## **SERVICE BULLETIN**

RE: Ford 6.8L E-series cutaway bus chassis with PennTex charging systems.

## **SVE BULLETIN**

### **OEM or Aftermarket Alternator Relocation (or Other High Current Line/Sources over 10 Amps) on 6.8L Gas Engine FEAD (Proximity to Throttle Body/ Throttle Position Sensor)**

# FORD THROTTLE POSITION SENSOR STYLES

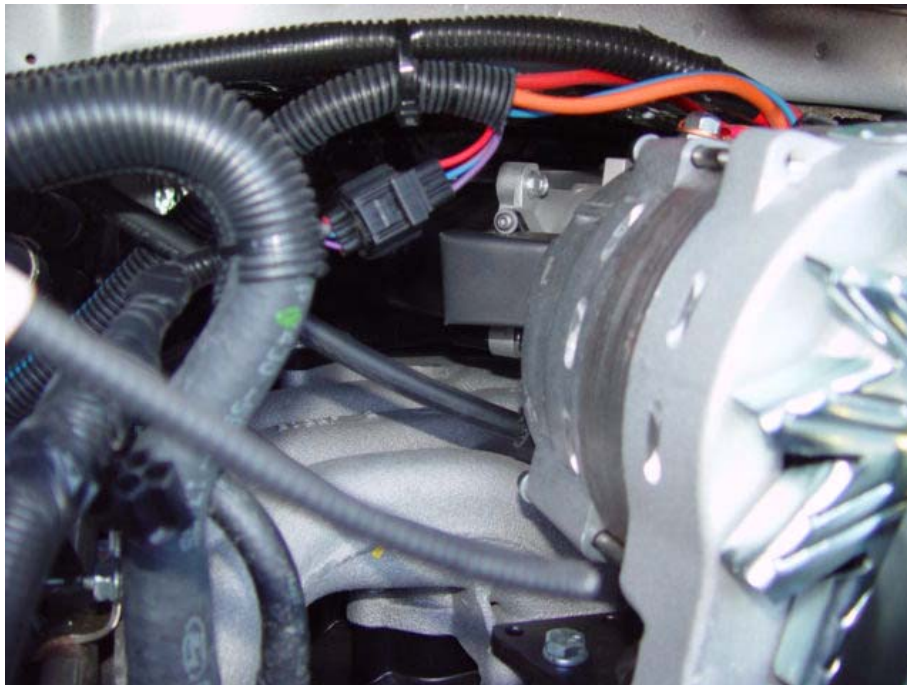
Earlier Potentiometer-style TPS

- \* Triangle Shaped
- \* Spring-loaded
- \* Not affected by magnetic interference

Later Magnetic-style TPS

- \* Rectangle Shaped
- \* Not Spring-loaded

The PennTex PX-7010 Shield is only designed to fit the later magnetic-style sensor

- \*Both sensors have the same mounting pattern and connector.
- \* Ford recommends heating the attaching screws before removal to loosen the LockTite on the screws. They can be broken off in the throttle body if this isn't done.

PennTex Industries  
TPS Shield (PX-7010) Installation on Ford 6.8L V-10 E-Series

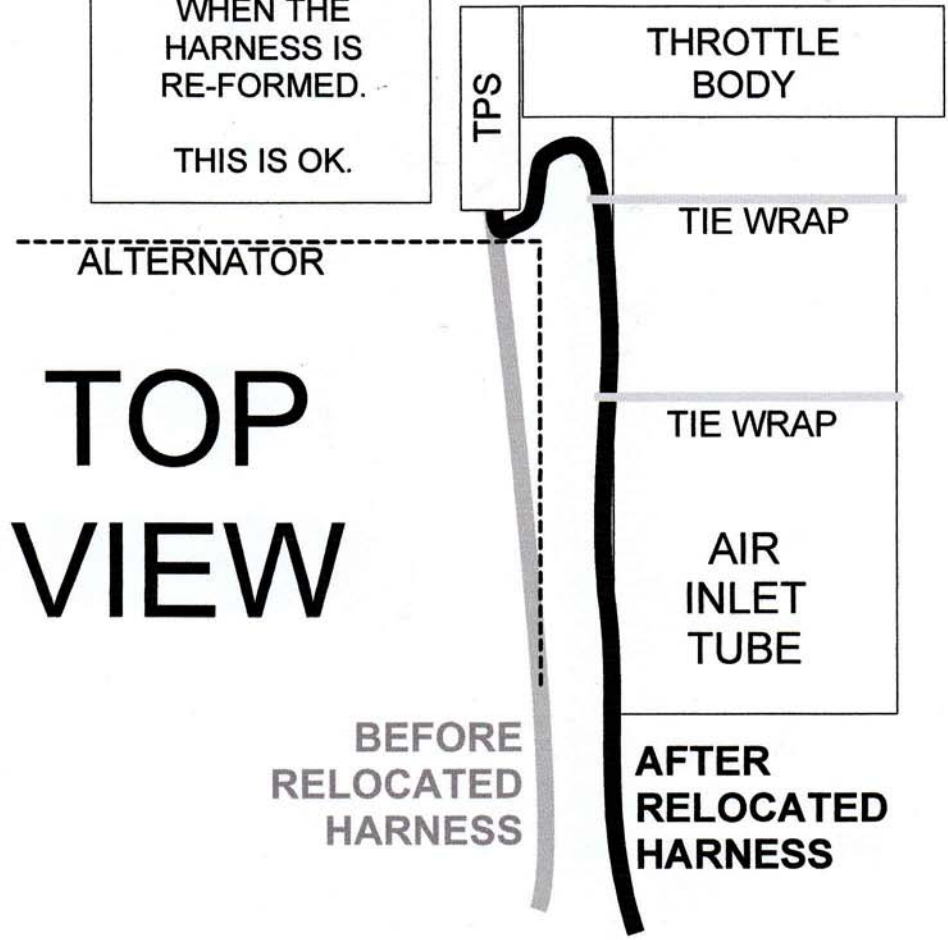
5. Apply a small blob (3/8") of sensor-safe silicone or similar suitable adhesive (**NOT INCLUDED**) to the underside of the TPS shield as shown in the picture below.

6. Install the TPS Shield onto the TPS Sensor and verify the position as shown below.

**THE PENNTEX PX-7010 TPS SENSOR SHIELD MUST BE  
INSTALLED PRIOR TO THE INSTALLATION OF THE  
ALTERNATOR ON ALL 2010 AND UP FORD 6.8L V-10  
E-SERIES CHASSIS.**
